This modification is required in order to fit a standard UK bath waste.

Modify the existing overflow to fit a new waste.

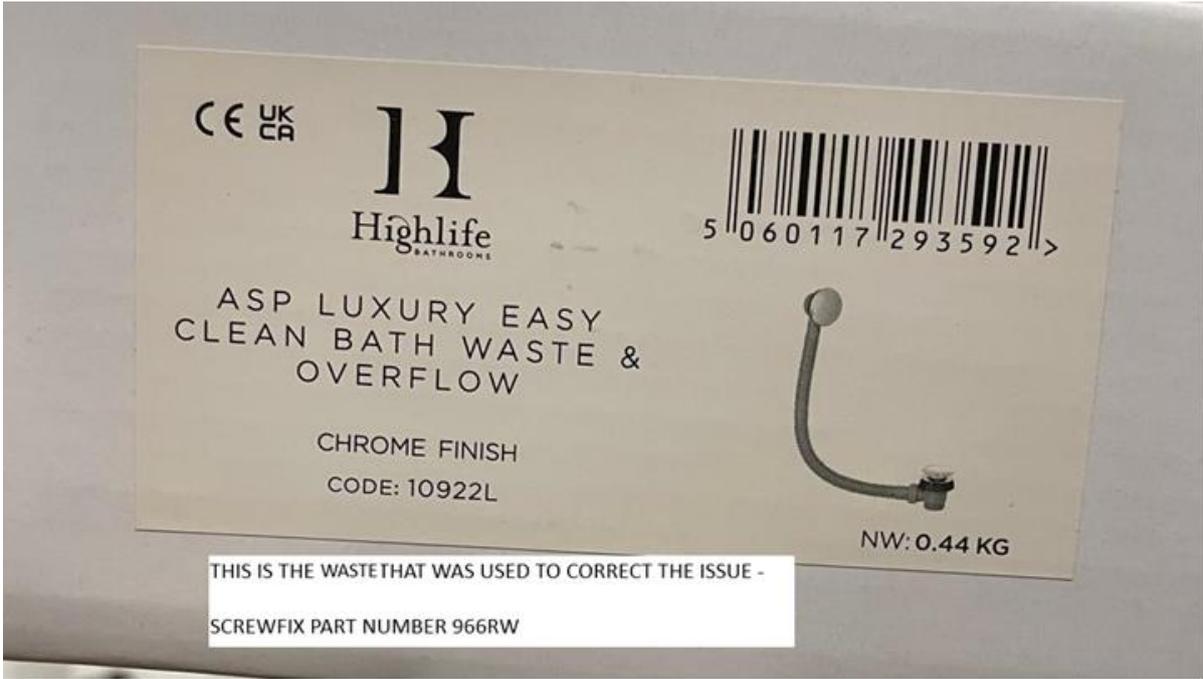
1. The waste on the Bath doesn't connect to UK fittings having a 28mm Flexible Outlet.
2. The waste body thread (where the bowl connects) isn't BSP, so a traditional trap couldn't be attached.
3. It also has a leak potential due to the absence of a seal in the hose bowl (if used).
4. Therefore, Discard this hose.

Using Screwfix 966RW - Use the parts following parts ;

Grey Waste Body – no innards

Side Nut

Side Tapered Seal

The bath was then water tested, the waste and overflow performed as expected.

We would need to supply the new waste and instruction with each bath as these parts are only available at Rubberduck Bathrooms, Screwfix and other plumbers merchants. The current parts aren't sufficient.
